**Addendum No. 1**  
**August 24, 2022**

Project name: Health Sciences Surgical Simulation Suite Renovation  
University of South Dakota  
Sanford School of Medicine  
OSE #R0622—05X  
Architecture Incorporated Project #:0217.2984.22

Scope of this Addendum:

6) DRAWING SHEET 8.31 – LOWER LEVEL FLOOR PLAN – PLUMBING & HEATING

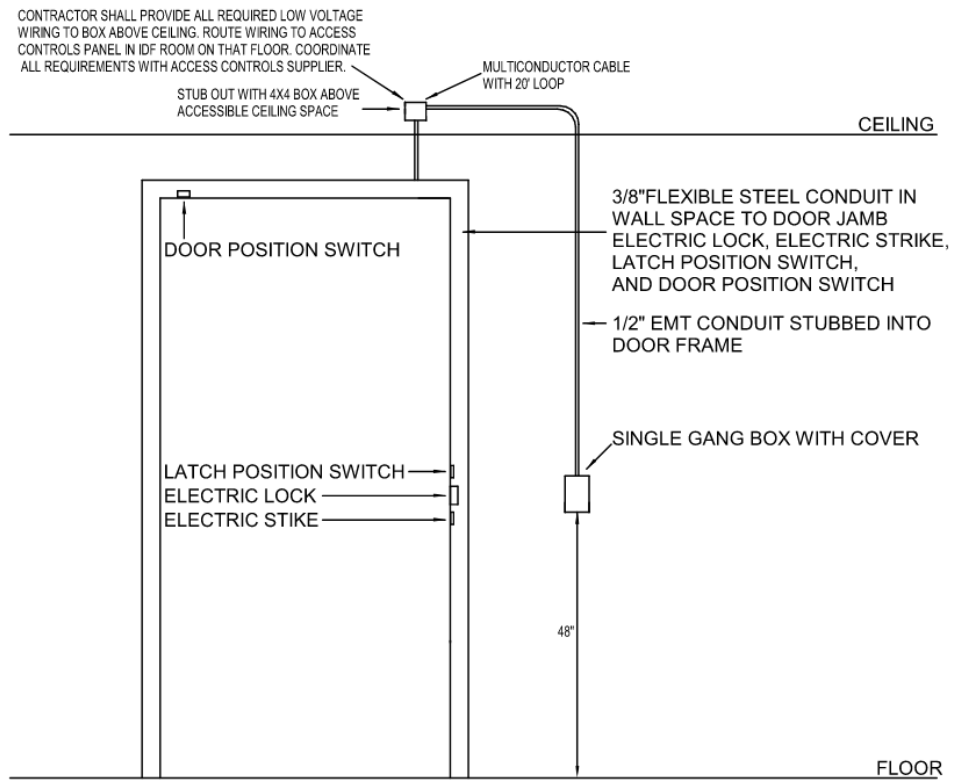
- a) Plumbing & Heating Note 4 shall read as follows: “1/2” O DN TO ALARM VALVE COMBO UNIT.”

**REFLECTED CEILING PLAN - LOWER LEVEL**

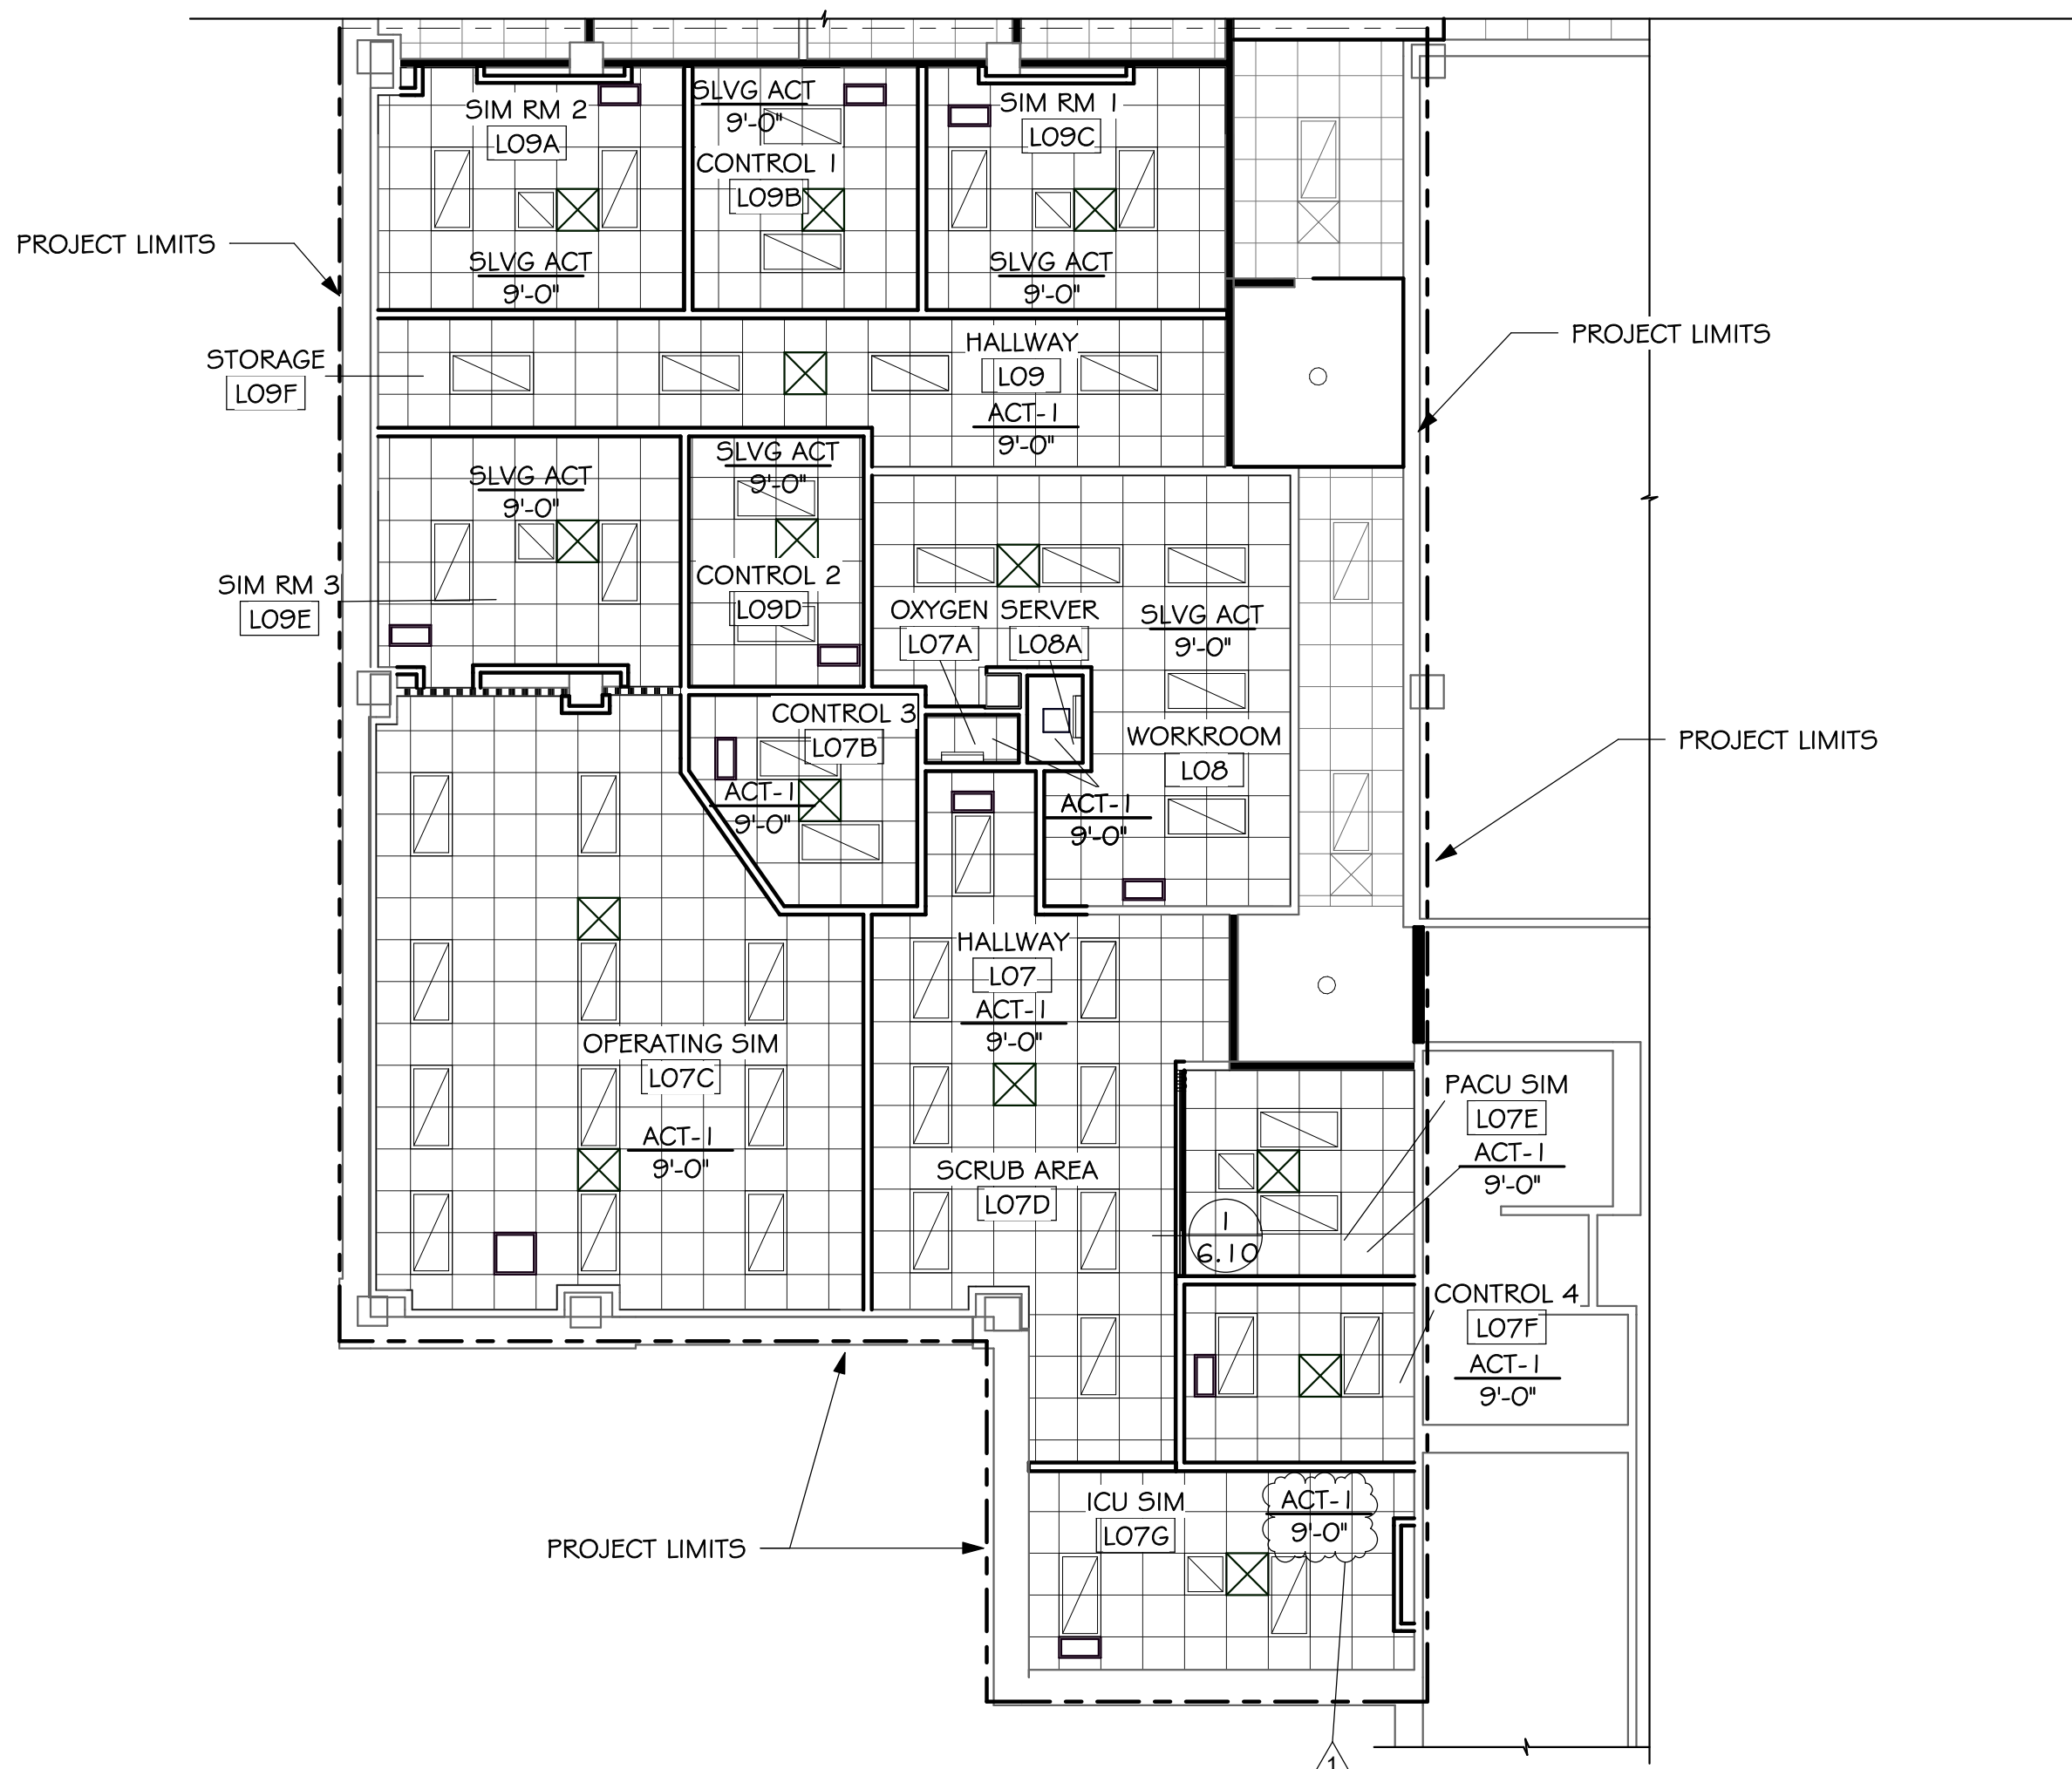
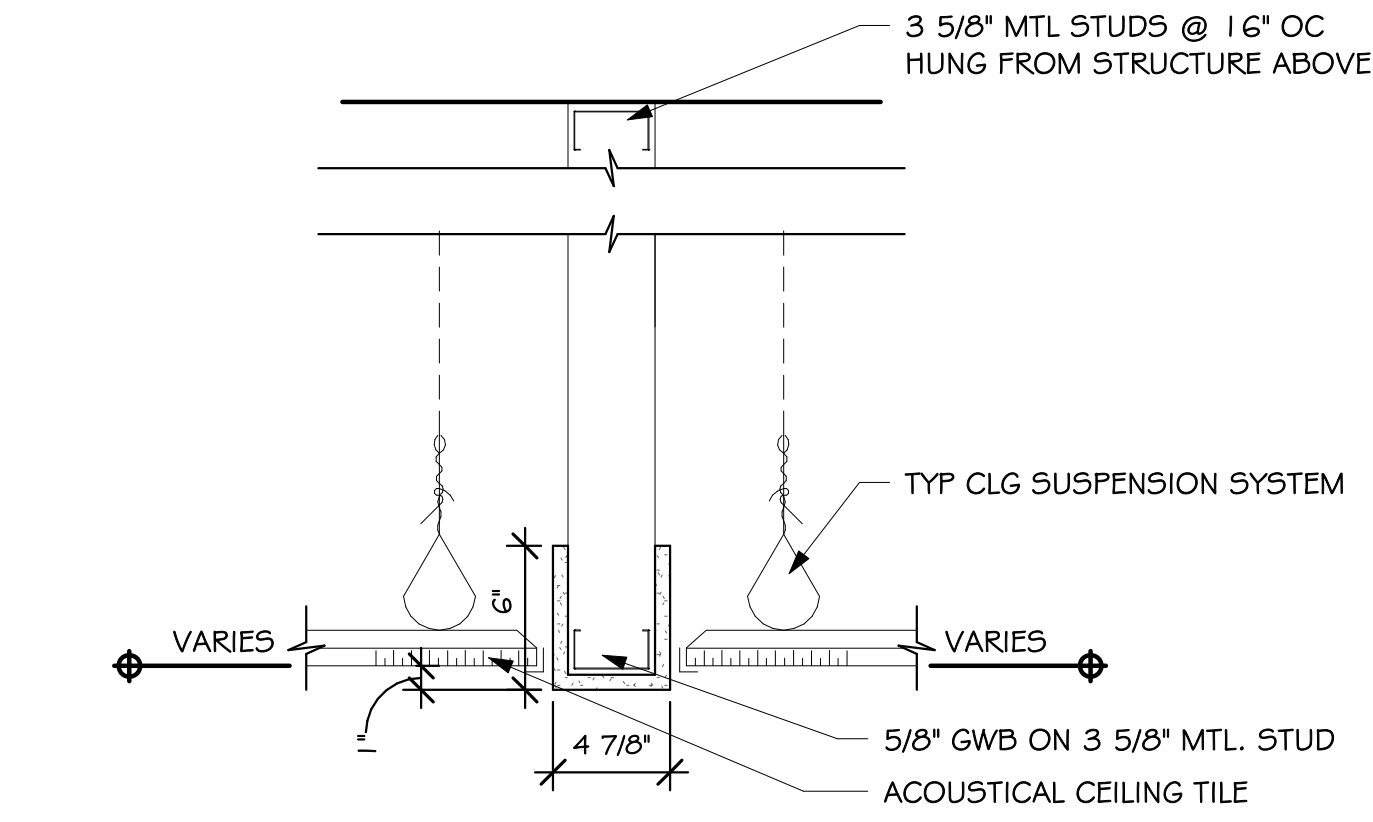
3) DRAWING 6.10 – REFLECTED CEILING PLAN

- a) Reference attached revised Reflected Ceiling Plan
  - i) Mechanical and Electrical devices are shown. Reference mechanical and electrical drawings for additional information.
  - ii) Ceiling type and ceiling height for ICU SIM L07G is provided.
